ADDENDUM NO. 5

BAGGAGE EXPANSION

Northwest Florida Beaches International Airport
6300 West Bay Parkway
Panama City, Florida 32409
Phone: 850-763-6751

Date of Issue: May 19, 2022

Q&R Item #36: Laydown Area Aerial Sketch

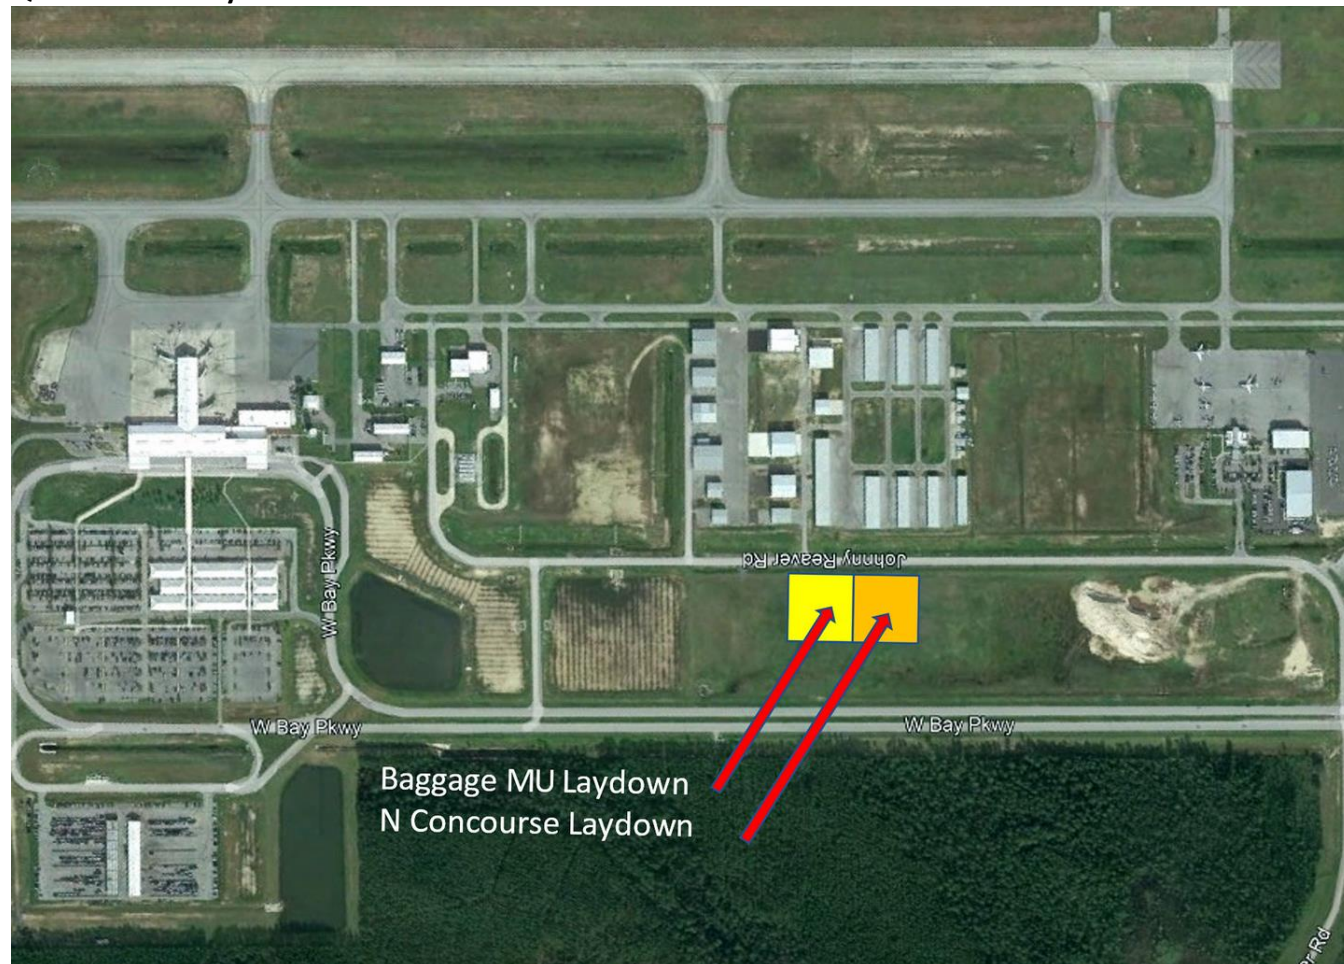
32	Is there a geotechnical report available for the contractor to view or should we assume that the existing soils are acceptable for the foundation that has been designed?	The existing soils are acceptable for the foundation that has been designed.
33	Who will be responsible for paying for the water for watering the sod that is to placed?	The Airport will be responsible for paying for the water for watering newly placed sod.
34	Will the contractor have to pay for temporary power and water?	No, the contractor will not have to pay for temporary power and water.
35	Please consider the attached substitute light fixture package for the baggage project.	AMA light fixtures are an approved substitute.
36	Please confirm the location of the lay down space available for this project.	The laydown area is in front of the T-Hangers on Johnny Reaver Road, South of the Terminal in the in-field parallel to the airport entry road. See attached aerial sketch of the location.

A-2.0.2

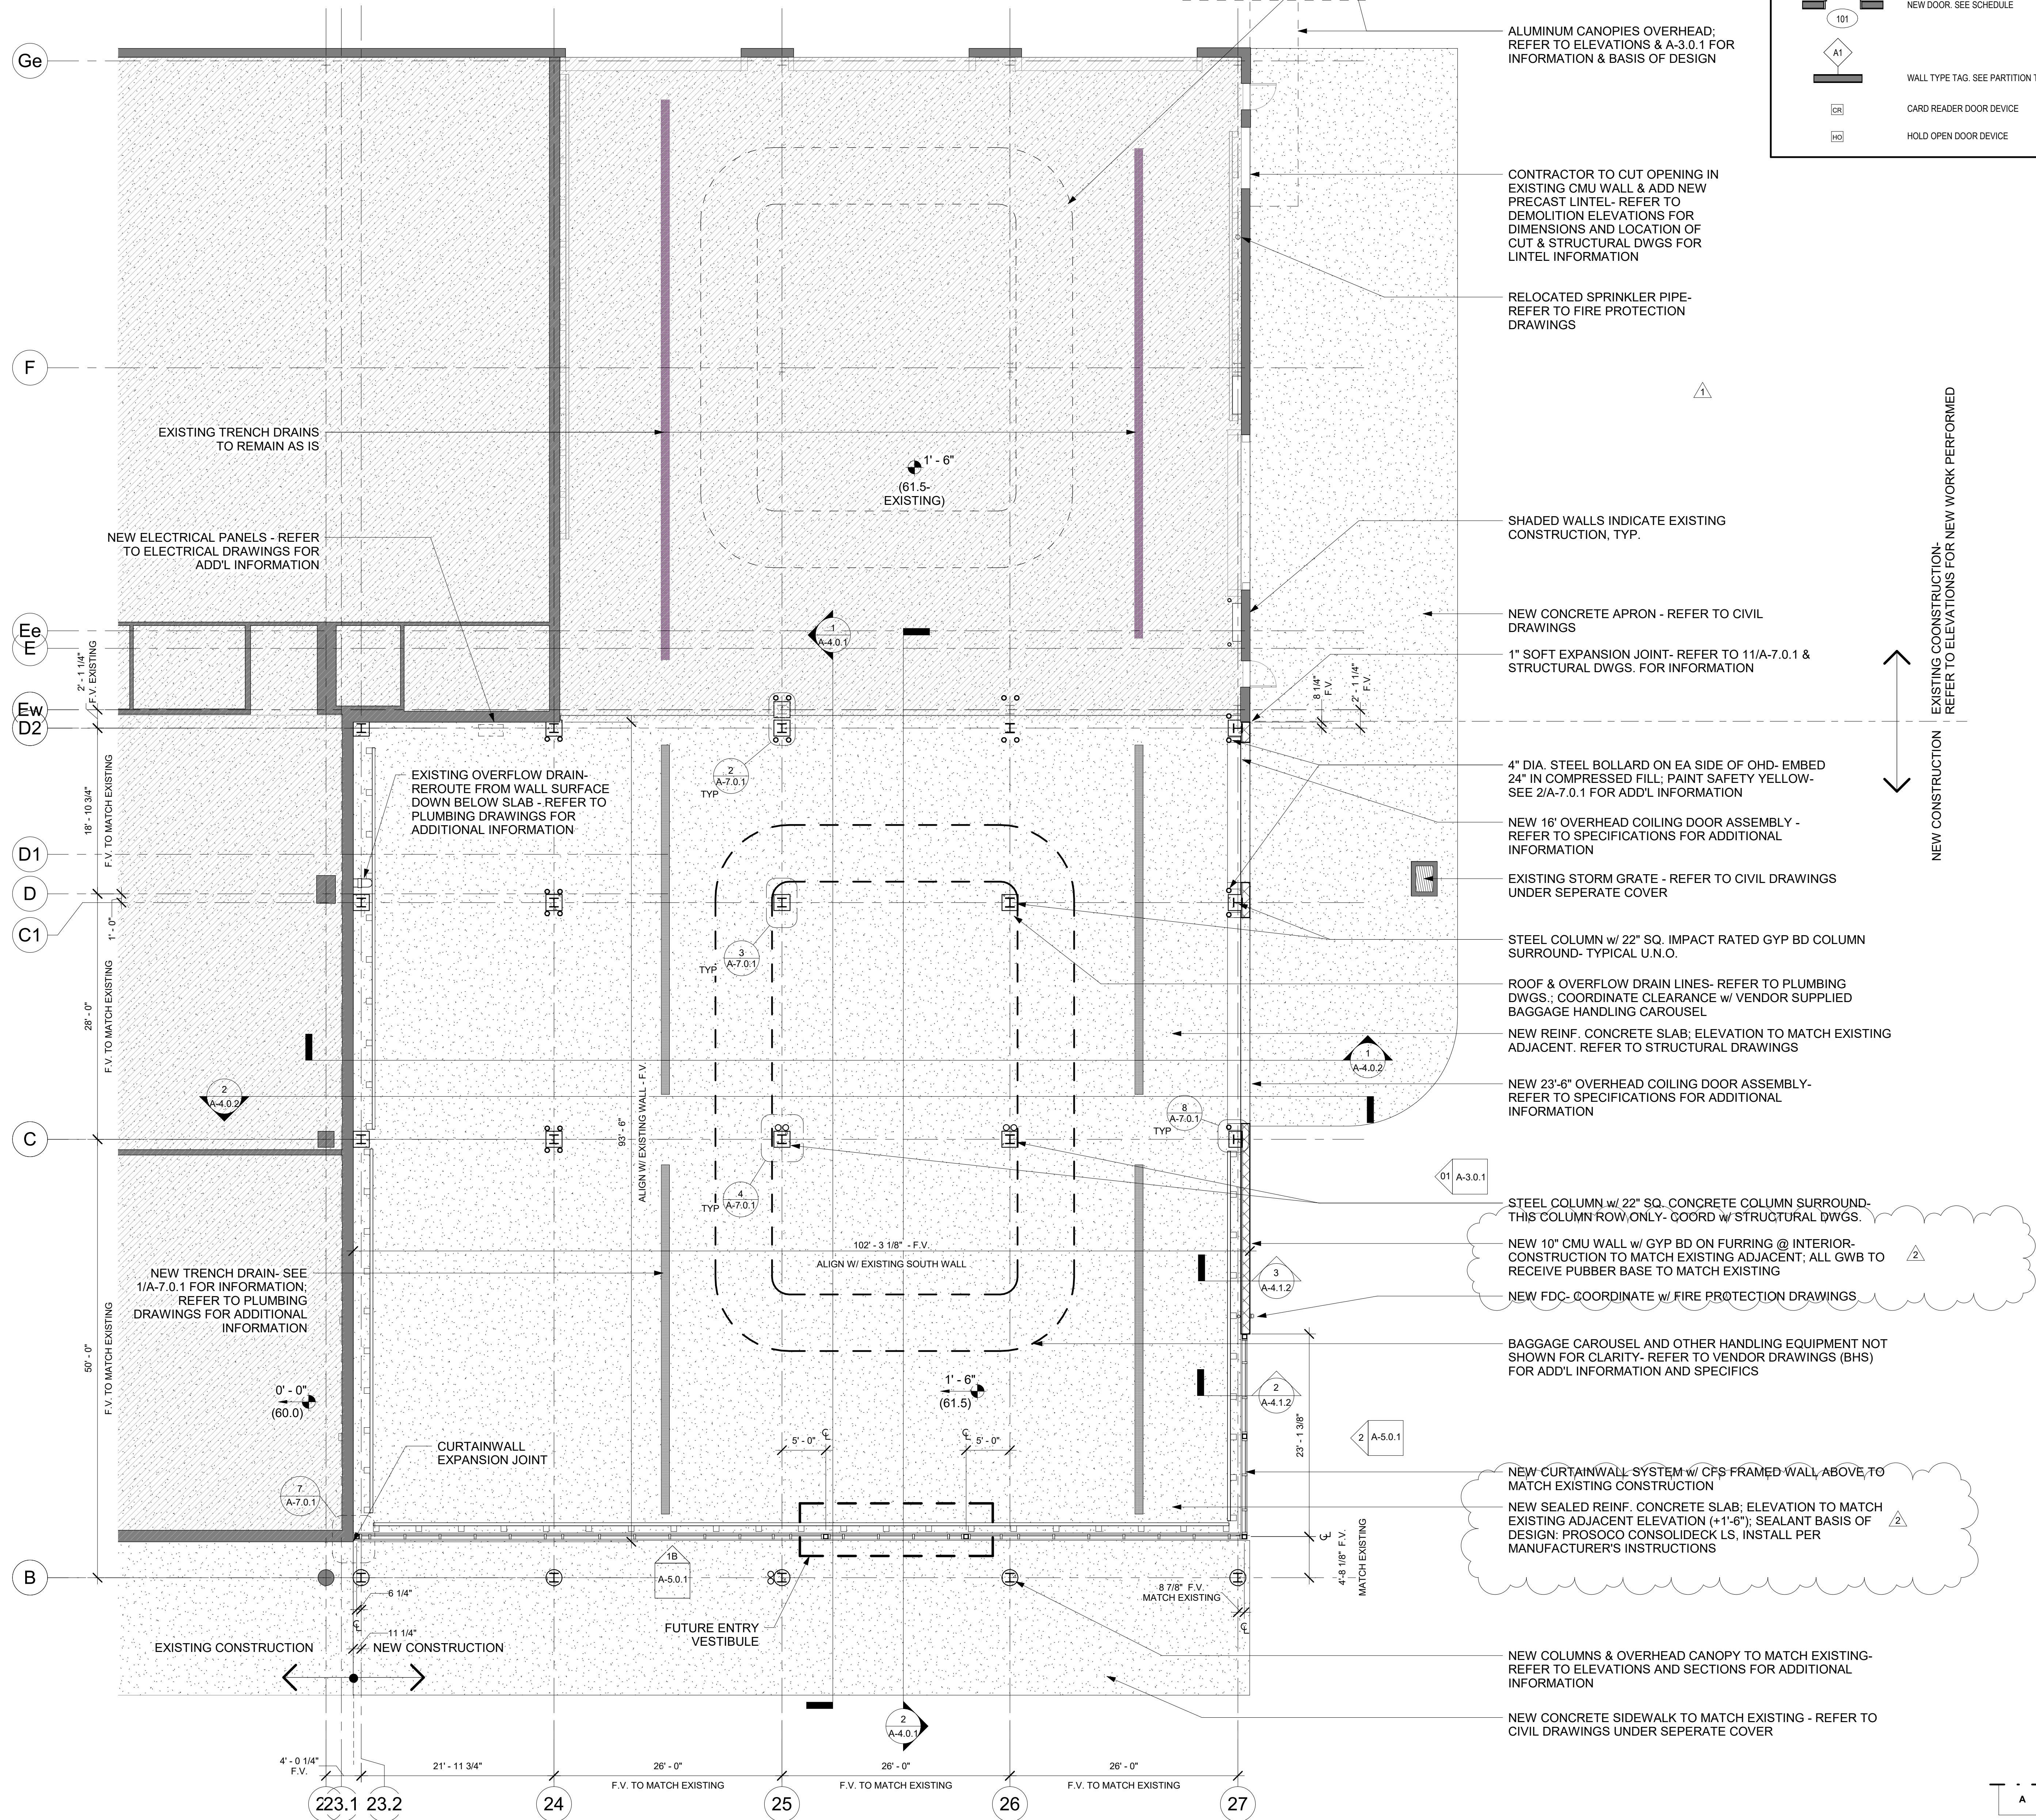
- A. ARCHITECTURE
 - a. REVISED: A-2.0.2 FLOOR PLAN, amend notes re: concrete floor sealer and rubber wall base
 - b. A-2.0.3 ROOF PLAN, added parapet roof ladder, added parapet roof ladder detail
 - c. REVISED: A-4.0.1 BUILDING SECTIONS, added parapet roof ladder
 - d. REVISED: A-4.0.2 BUILDING SECTIONS, added parapet roof ladder, revised/added GRV units to rooftop for clarity
